AGENDA
CITY OF GLENWOOD SPRINGS
Planning and Zoning Commission
Regular Meeting
NOVEMBER 17, 2020
Council Chambers, First Floor
101 W. 8TH STREET
6:00 PM

Date: November 17, 2020
 To: Planning and Zoning Commission
 From: Trent L. Hyatt, Senior Planner
 Subject: #49-20 – City Electric and Broadband Operations Building

Utility & Service
Plan

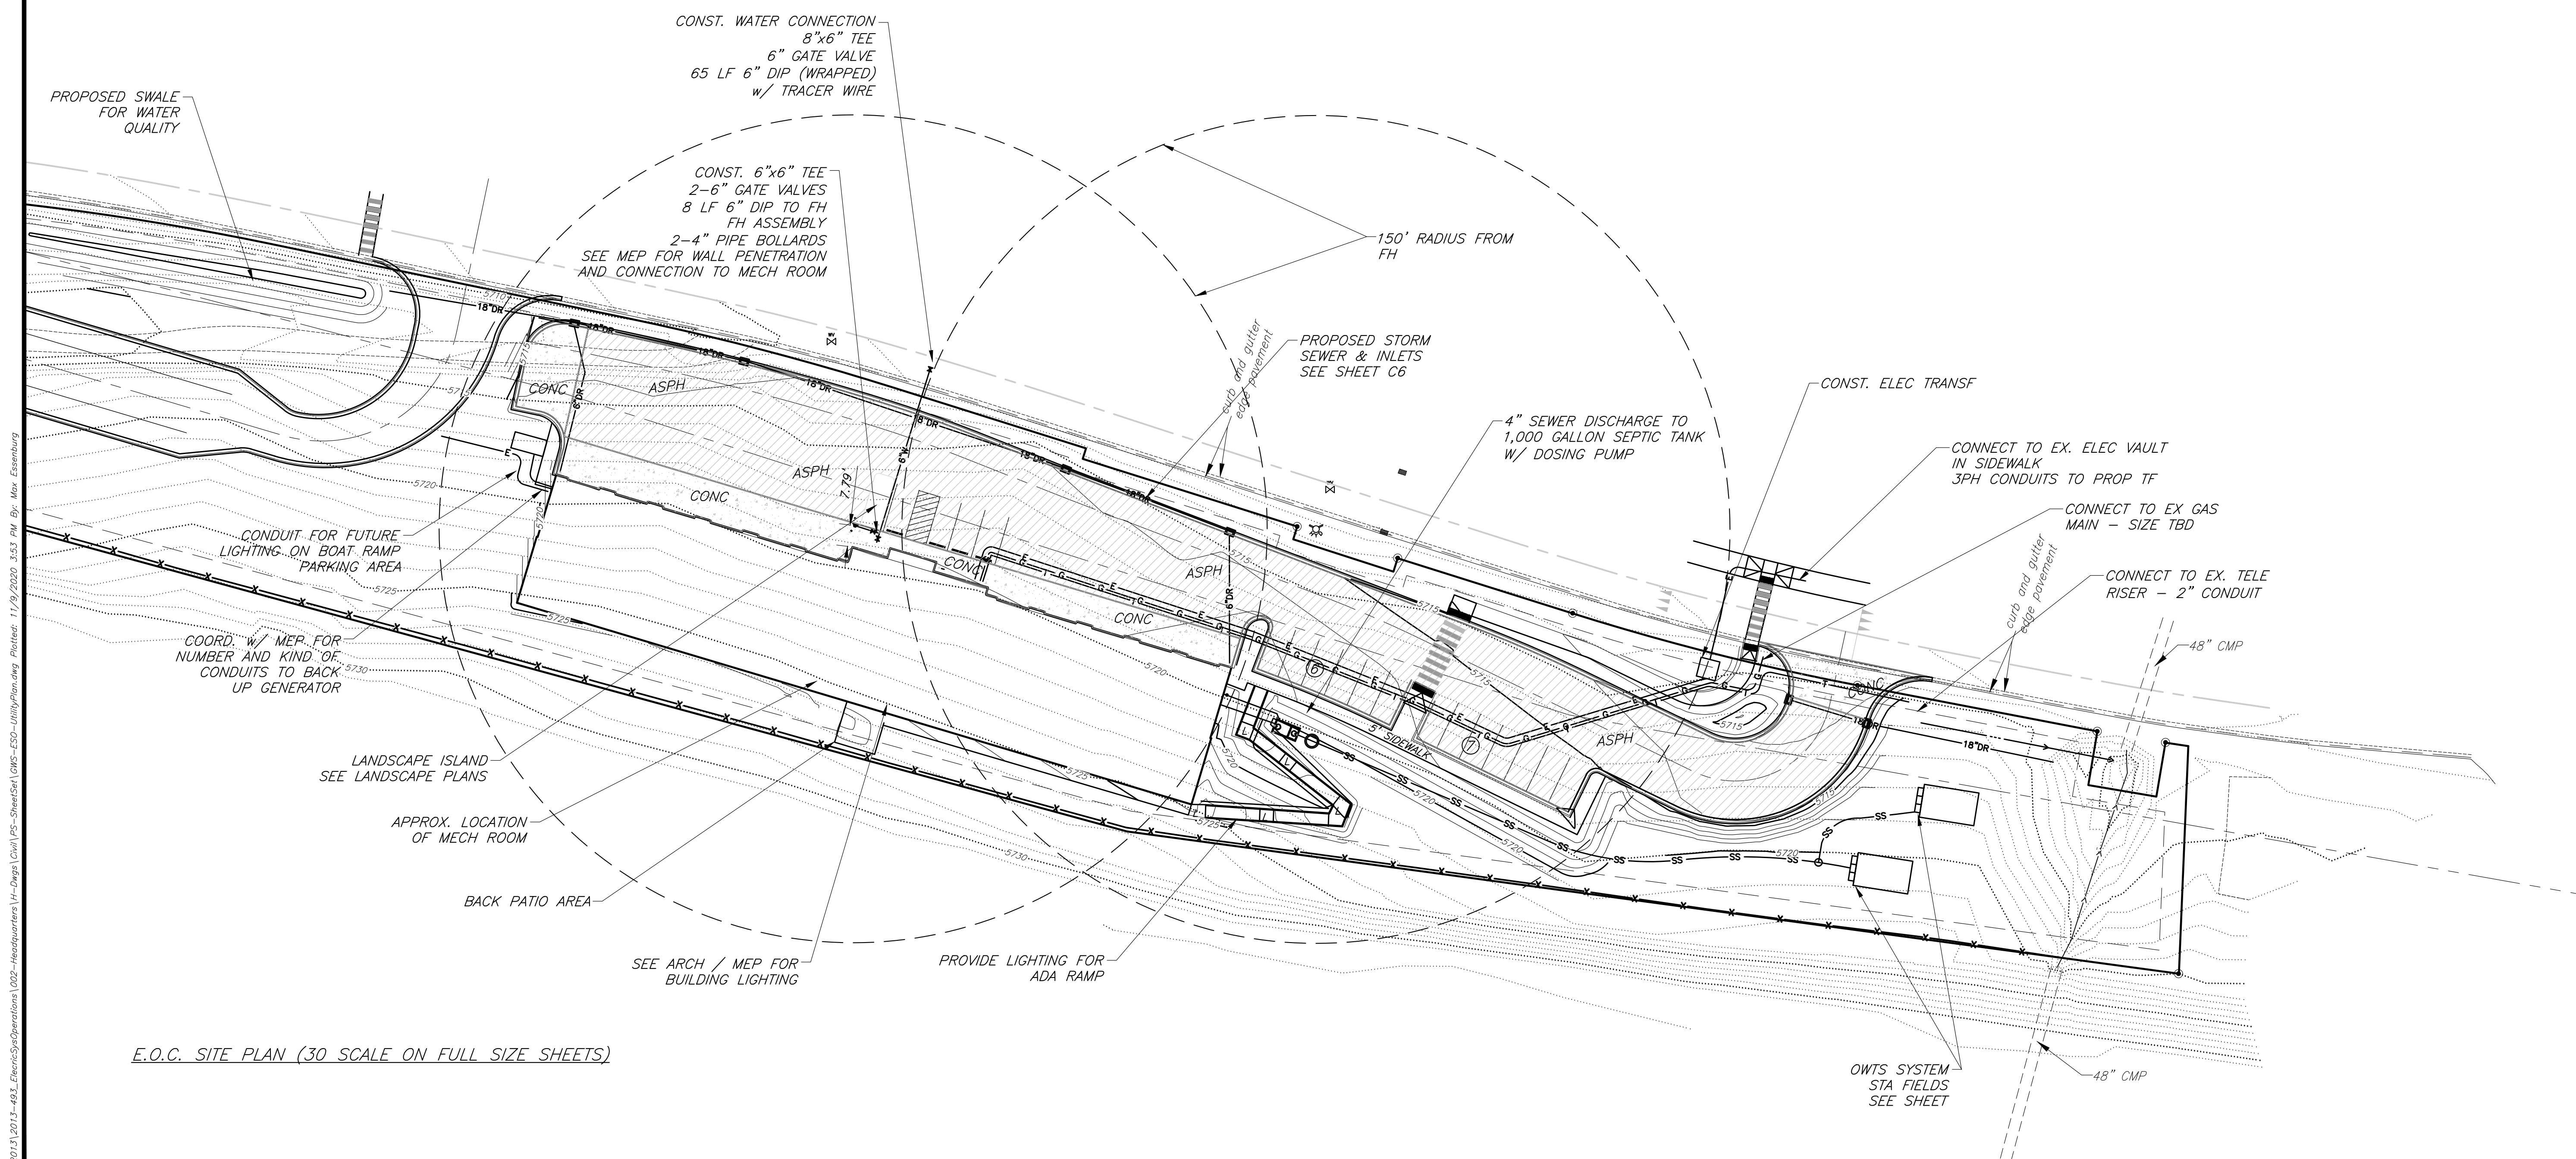
7. Sheet C8 OWTS plan

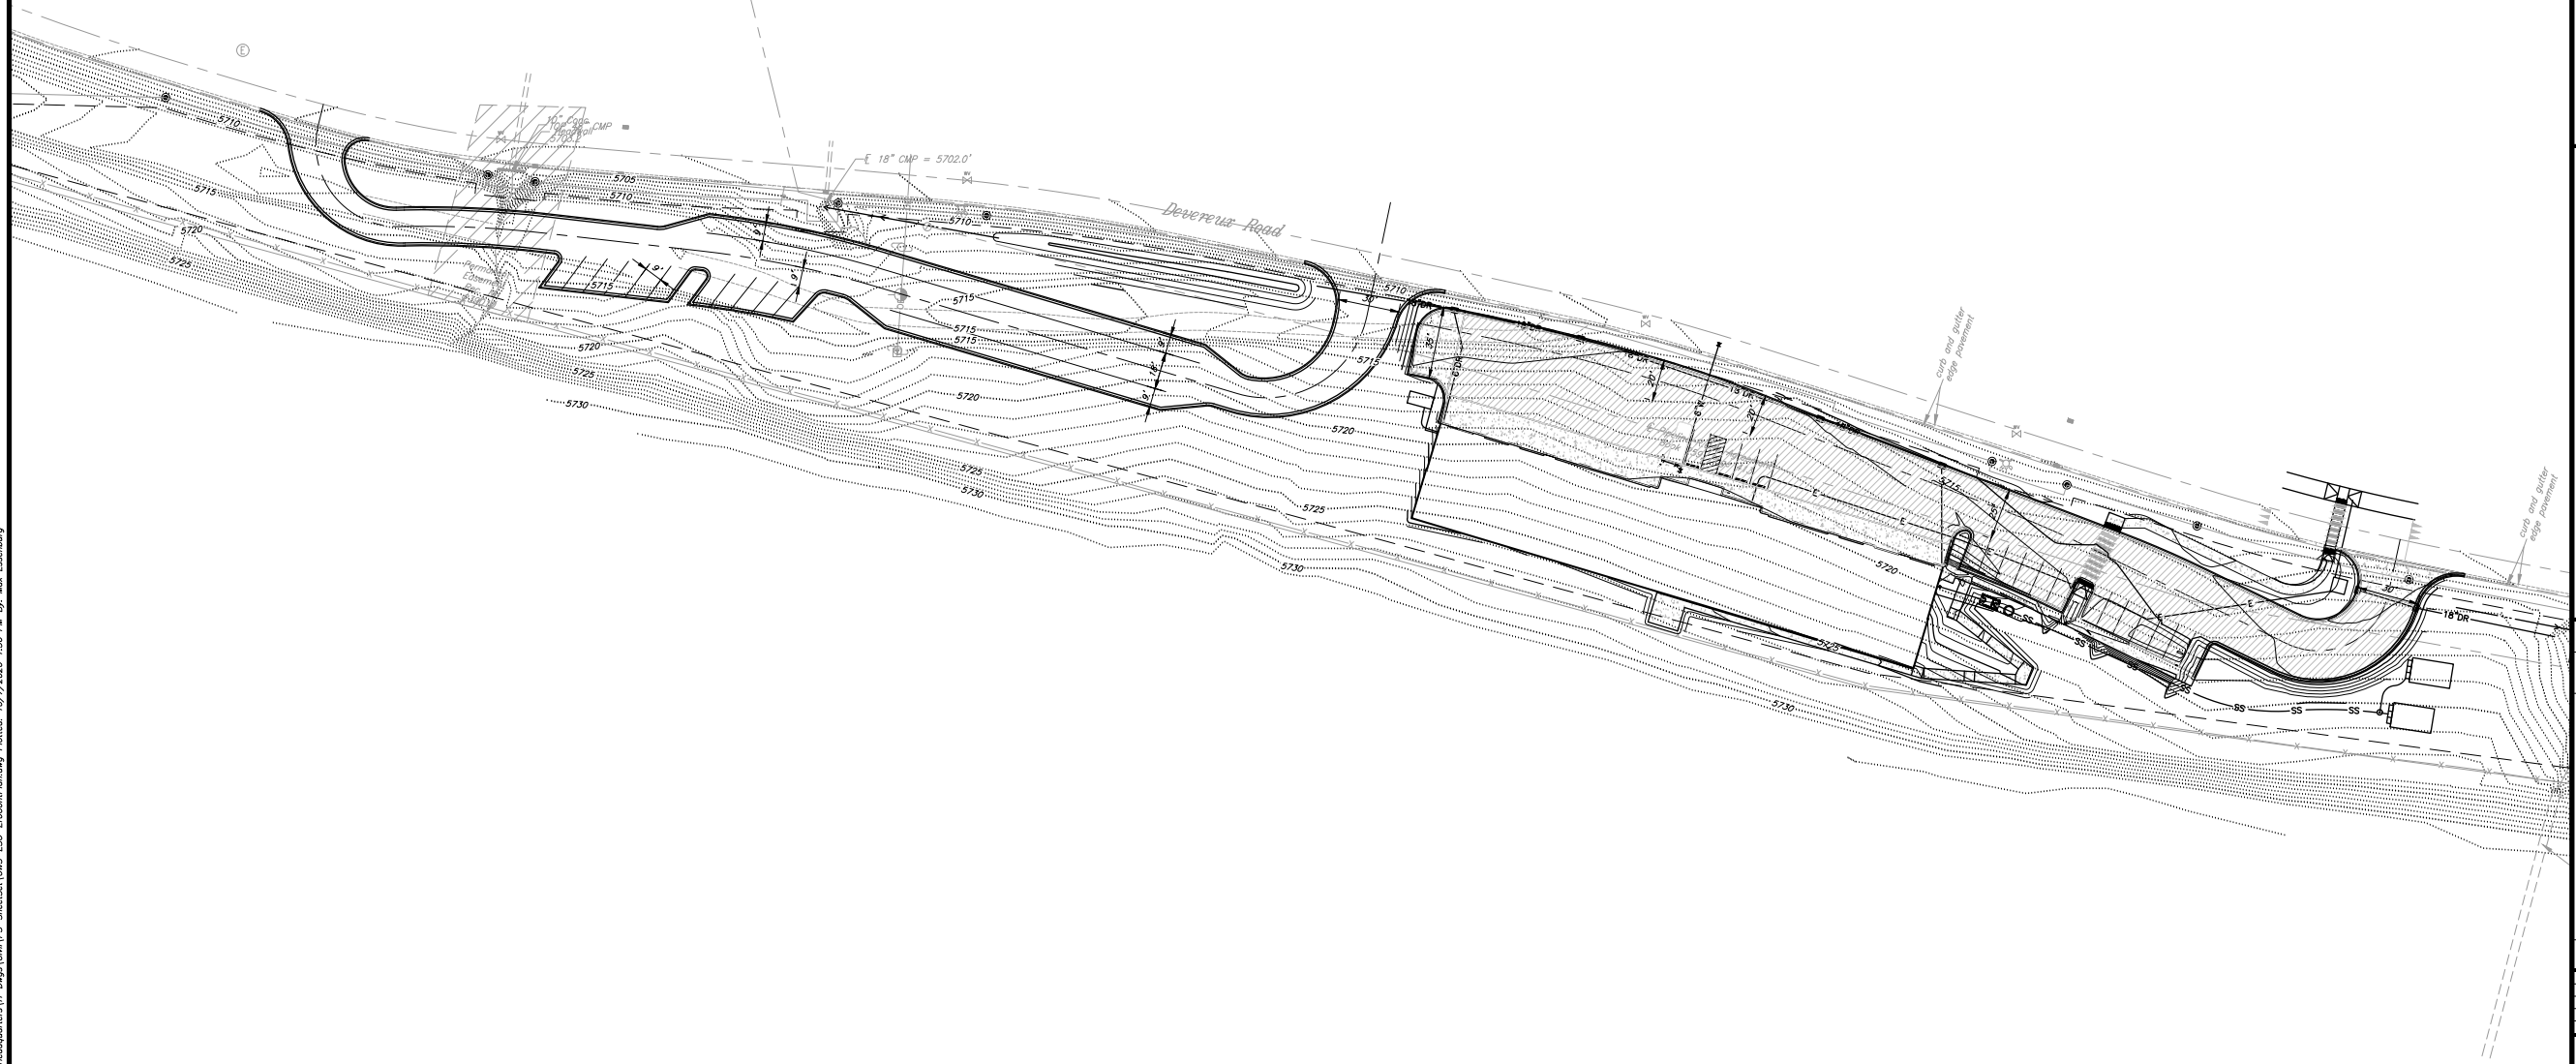
where is water quality provided for this outfall?
